Assessing new nuclear power station designs

Generic design assessment of Hitachi-GE's Advanced Boiling Water Reactor

Assessment report - AR04 Gaseous waste

Figure 3: Mean normalised annual gaseous discharges of iodine radionuclides from BWRs 2005 to 2013

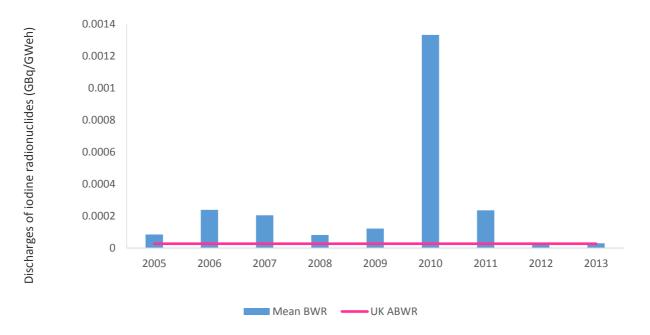
Estimated annual discharges of gaseous iodine radionuclides from the UK ABWR are lower than the mean annual discharges of gaseous iodine radionuclides from other operating BWRs and sit at the lower end of the range of data obtained for operating BWRs.

Figure 5: Mean normalised annual gaseous carbon-14 discharges from BWRs 2005 to 2013 Pink line shows normalised UK ABWR estimated annual gaseous carbon-14 discharges

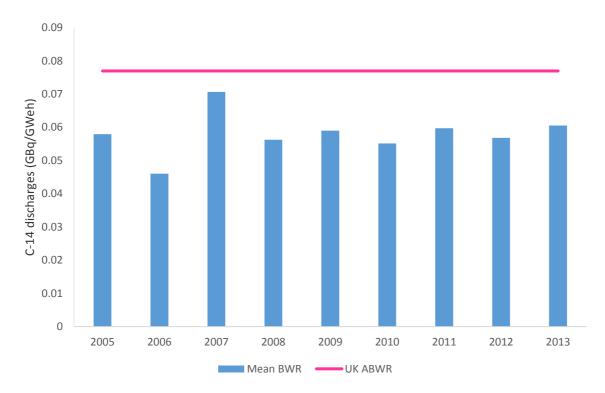
Estimated annual discharges of gaseous carbon-14 from the UK ABWR are higher than the mean annual discharges of gaseous carbon-14 from other operating BWRs and sit in the upper end of the range of data obtained for operating BWRs. Hitachi-GE has not provided an explanation as to why the gaseous carbon-14 discharges from the UK ABWR are higher than the mean carbon-14 discharges from other operating BWRs. At the time of writing, we are pursuing this with Hitachi-GE.
